Submission re Pinehaven Floodplain.

Pinehaven Stream Floodplain Proposed Flood Management Plan

The Green
Corridor that is
proposed for
removal.

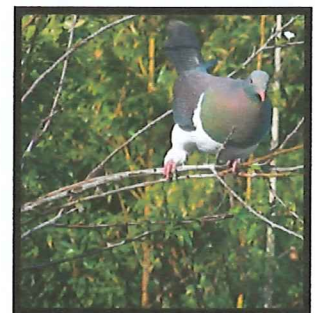
The birds will be sad if this food source was removed.
